Standing Rock Sioux Tribe

**Call for the Shutdown of the
Dakota Access Pipeline
and
Comments on the Army Corps of Engineers'
Draft Environmental Impact Statement**

December 13, 2023

Figure XI.4. Lake Oahe Geographic Response Plan (2018) Control Point #1 Compared to Satellite Imagery (4-8-22).

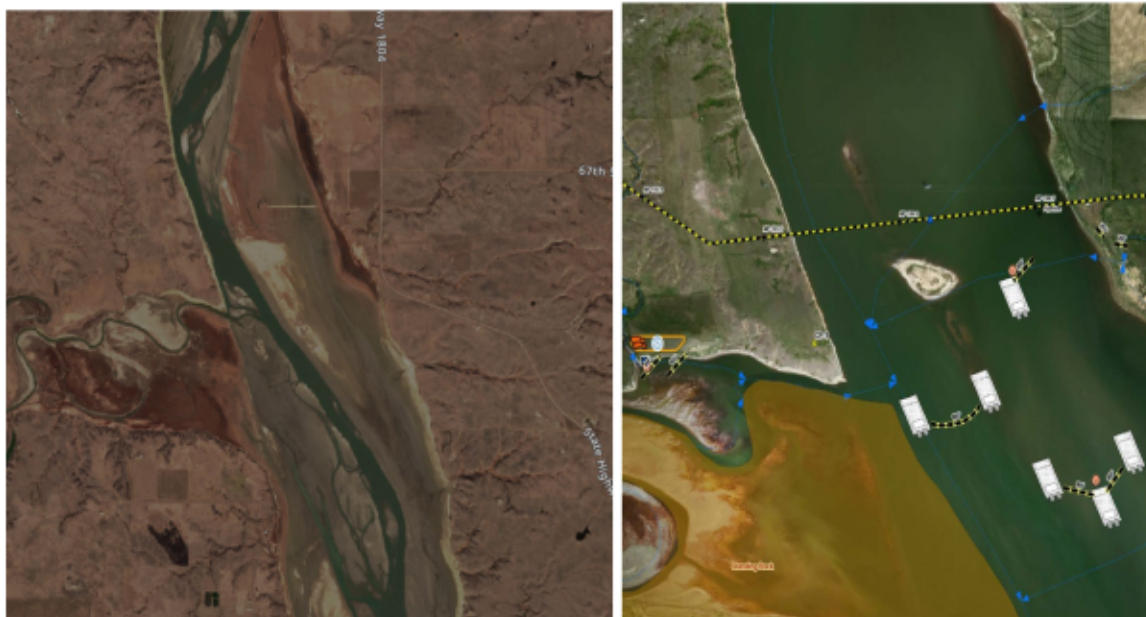
The Control Point 1 (CP-1) area just downstream from the DAPL undercrossing is the most critical for accessing Lake Oahe near the source of a DAPL spill and engaging in spill mitigation before greater volumes of oil can travel downstream and more seriously impact water intakes and the environment. Figure x.3 compares the CP-1 area from satellite imagery to Energy Transfer’s GRP¹⁶¹ and the severely braided water in Lake Oahe nearest the DAPL undercrossing. Energy Transfer’s GRP requires significant boat and skimmer travel from boat ramps to their identified oil spill Control Points. The upper Control Points areas in Lake Oahe are now in most cases exposed river bottom. Identified locations for vacuum trucks and tanks on the north bank of the Cannon Ball River used for oil clean-up are now distant from the braided water and unusable.

The Corps has responded to these issues with unsupported assertions of feasibility and claims of equipment availability not in the company owned inventory of staged emergency response equipment. The low water listed equipment is labeled as external with no location provided implying the equipment will need to be procured in the event of a spill. Lake Oahe boat ramps in the vicinity of the response control points during the low water crisis have largely unavailable (Figure x.4).

Figure A-13. Time history of total hydrocarbon concentration for the 95th percentile unmitigated FBR scenario for surface oil exposure at the Lake Oahe pipeline crossing location, drinking water intake 13.

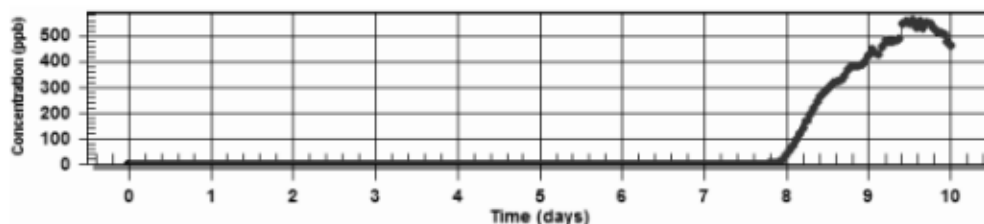
Energy Transfer’s oil spill modeling is incomplete which is not addressed by the Corps. All of the model simulations in the three oil spill modeling reports track the movement of oil for 10 days following the hypothetical spill. Additionally, the study boundary for the model simulations is terminated at 74.67 miles downstream of the Lake Oahe crossing. This is just before the SRST drinking water intake (intake #14, at 75.41 miles downstream). Given the SRST’s high level of concern surrounding possible contamination at the SRST drinking water intake, the intake should have been included in the model domain. Despite not being included in the model domain, the DEIS concludes in Section 3.3.1.3¹⁸⁸ that the SRST intake “was not predicted to be impacted within the 10-day period under any modeled scenario.”

In the oil spill modeling report, time series of subsurface oil concentrations show substantial concentrations of oil at intake 13 at the end of the 10-day model simulation. For example, see Figure A-13 of the report, reproduced below, which shows the subsurface concentration of total hydrocarbons peaking just before the end of the simulation. The oil spill modeling report also concludes that it may take 10 days for contaminants to initially reach intake 11 (one of the three downstream intakes where subsurface concentrations were analyzed in more detail).¹⁸⁹ A longer simulation duration would have provided more details about the ultimate fate and transport of the spilled oil, impacts on downstream receptors, as well as areas where resurfacing of entrained oil would be more likely.
